**Disposition of comments on:
FCD ISO/IEC 14443-4:2008/FPDAM2 identification cards —
Contactless integrated circuit(s) cards — Proximity cards — Part 4:
Transmission protocol — AMENDMENT 2: Bit rates of fc/8, fc/4 and
fc/2, protocol activation of PICC Type A and frame sizes from 512 to
4096 bytes**

Ballot is in SC17 N 4214 = WG8 N 1826
Ballot Result is in SC17 N 4321 = WG8 N 1840

Reinhard Meindl, Austria

[JP Annex-1] PDAM 14443-4:2008/Amd.2

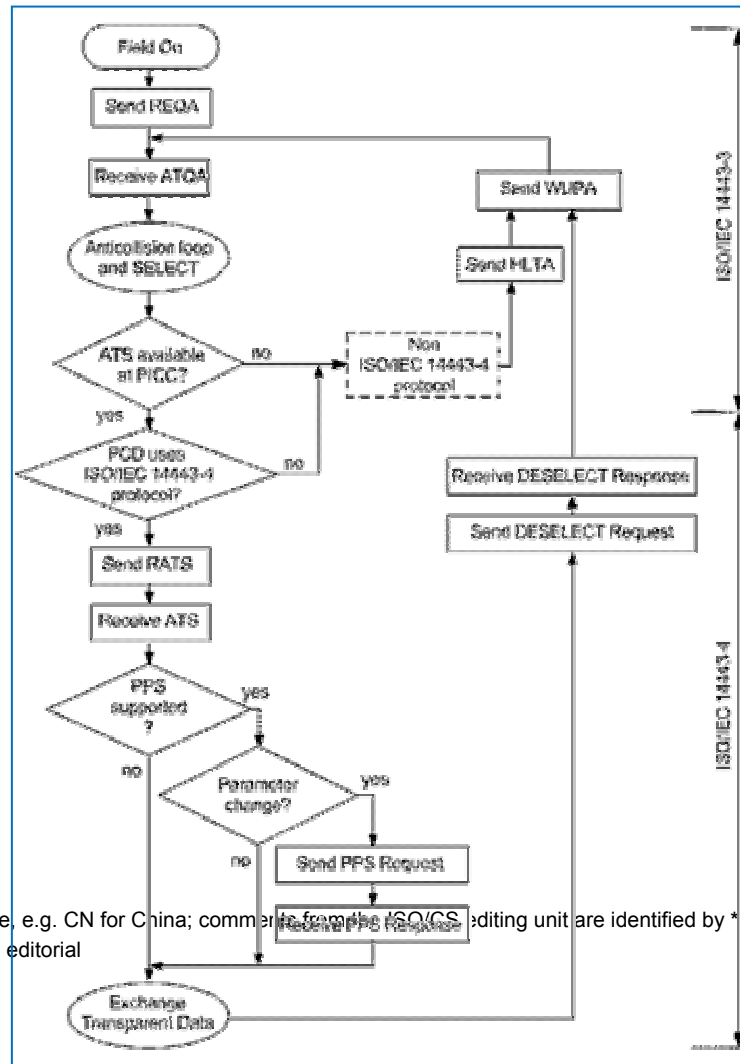
FR1	Title	Front page and 1 st page and	ED	Consistency with 14443-3/FPDAM2 and with title in French	Replace "and frame sizes from 512 to 4096 bytes" with "and frame size from 512 to 4096 bytes"	accepted
JP4	5	New dash	te	<p>New dash, which is specified in PDAM 14443-4:2008/Amd.2 is missing(See JP Annex-1)..</p> <p>Deleting the new dash is out of consensus between the delegates of SC17/WG8 Ispra Meeting.</p>	<p>Add following new dash</p> <p>"</p> <p>— The PICC may be set to HALT state, using the HLTA command as defined in ISO/IEC 14443-3, if no ISO/IEC 14443-4 protocol is used at PCD.</p> <p>"</p>	Resolved By modification of 3 rd dash and adding a note This dash describes optional behaviour only
JP5	5	Figure 1	te	<p>The new Figure 1, which is specified in PDAM 14443-4:2008/Amd.2 is missing(See JP Annex-2).</p> <p>Deleting the new Figure 1 is out of consensus between</p>	Insert the new Figure 1 as described in PDAM 14443-4:2008/Amd.2.	Resolved By new figure

Add new dash after the end of fourth dash of 5 with following:

-
- The PICC may be set to HALT state, using the HLTA command as defined in ISO/IEC 14443-3, if no ISO/IEC 14443-4 protocol is used at PCD.
-
